Re: The Villages at Cricket Lane  
55R Pearson Drive

## M E M O R A N D U M

**RE:**                Comprehensive Permit Application and Site Plan Peer Review  
                          Village at Cricket Lane, Newbury, Massachusetts

Peer Review Comments  
The Village at Cricket Lane  
Wetland Details (sheet 16)  
Last revised 8/17/2020

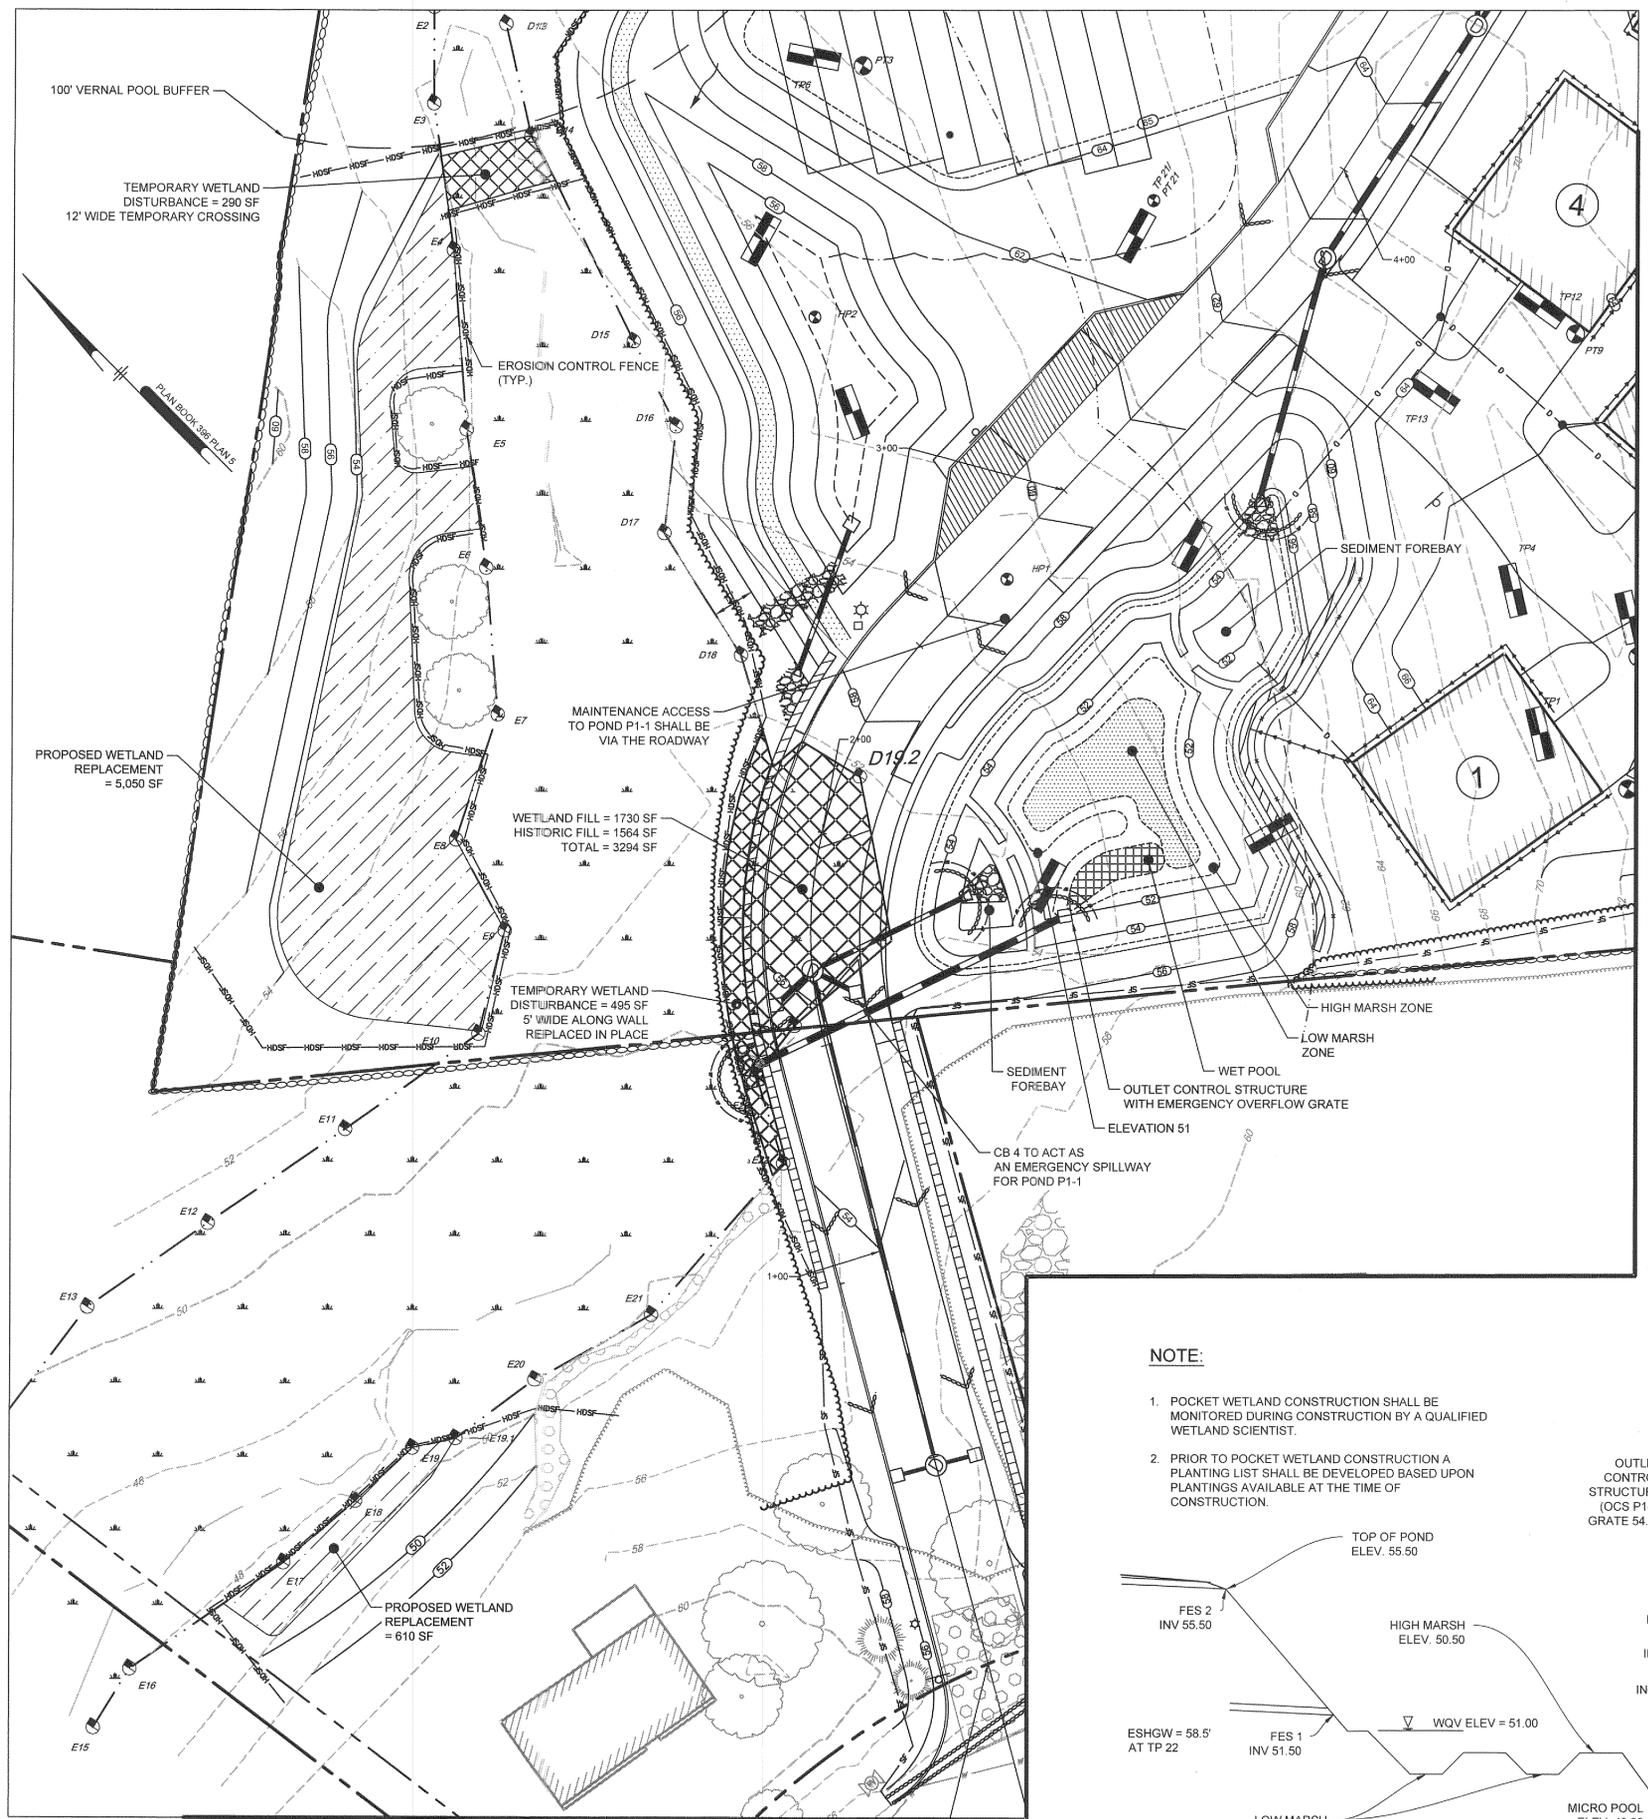
The Wetland Details plan (sheet 16) depicts a proposed 5,050 SF Wetland Replacement Area with grading, tree protections to the presumed drip line for 3 existing trees, a Wetland Replacement Planting Table, Wetland Seed Mix, and Performance Specifications. While this is a vast improvement, the Wetland Replacement Table omits the number of required trees and shrubs to confirm proper planting densities, and includes eastern white pine (*Pinus strobus*) which is not a wetland plant. Please add tree and shrub quantities and either remove *P. strobus* or replace with a more appropriate tree species. Additionally, see Attachment A for LEC's markup comments on Sheet 16.

In my haste to complete my review this past Sunday, I failed to cross-check my prior 10-9-2020 comments on Plan Sheet 16 to the updated plans. Based on my initial review of the plans you just sent over, the attached comments were not incorporated into Plan Sheet 16. Please make these changes.

Also, we will work on making the changes to sheet 16 as outlined in your attachment. I have also verified the number of shrub plantings along the C and D series wetland buffer. The plans will be revised to reflect 45 and 20 respectively.
